UNITED STATES PATENT AND TRADEMARK OFFICE

Office Action Summary	Application No. 10/530,407	Applicant(s) CONTA ET AL.	
	Examiner Sarah Al-Hashimi	Art Unit 2853

DETAILED ACTION

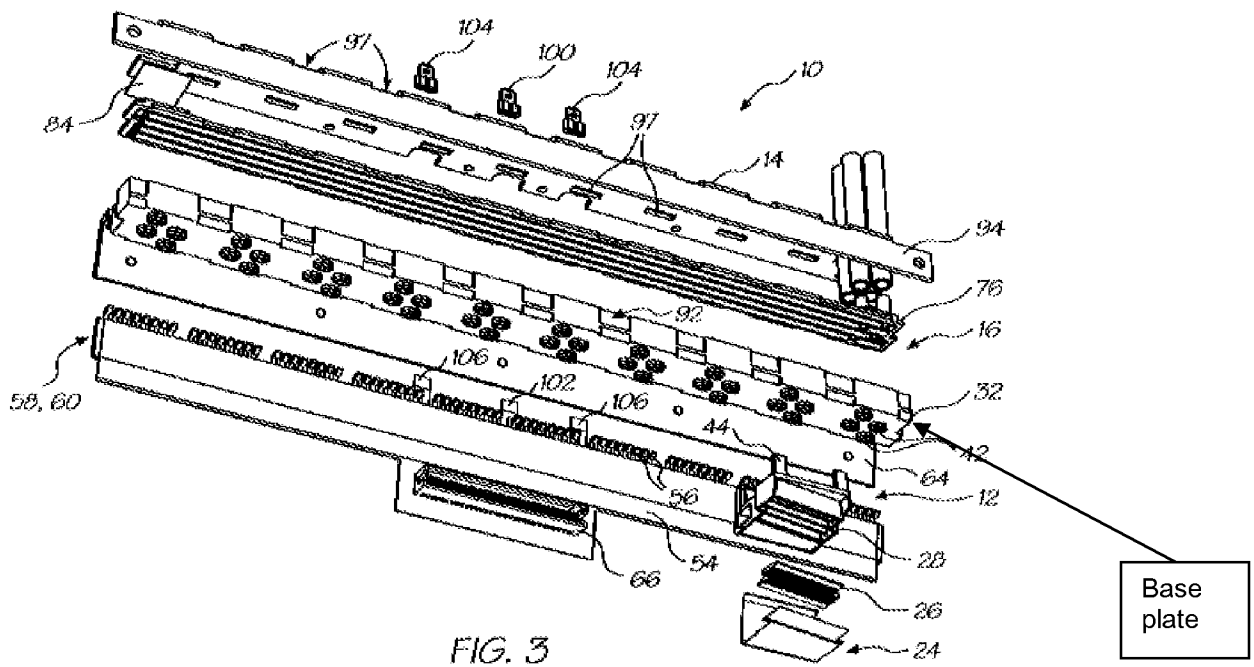
Claim 1: ejection nozzles aligned along a same direction (**col 3 line 11**), a support common to the modules (**fig 1 #16**) and hydraulic tight means (**fig 2 #28**), and in which: the support comprises a base plate of rigid material (**see figure below**) that defines through its thickness a feeding duct for the ink (**fig 3 #42**) which, in use, is substantially parallel to the line of printing; and the ejection modules are mounted side by side on said support plate (**fig 1 #12**) and with the chambers arranged in a line along the same direction (**fig 8 #30**) and in hydraulic connection with the feeding duct , said

hydraulic tight means achieving a hydraulic tight connection between the said modules and the feeding duct (**fig 2 #28**).

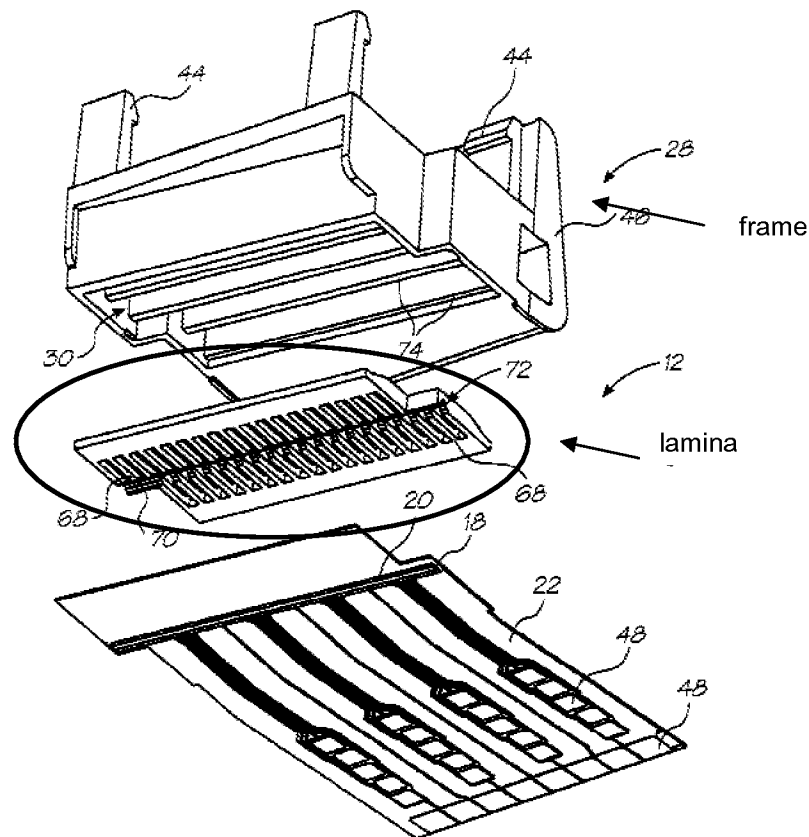
Claim 2: said hydraulic tight means comprises a lamina mounted between the modules and, through a frame, the support (**see figure below-48 and 44 comprise a frame attaching to the support**).
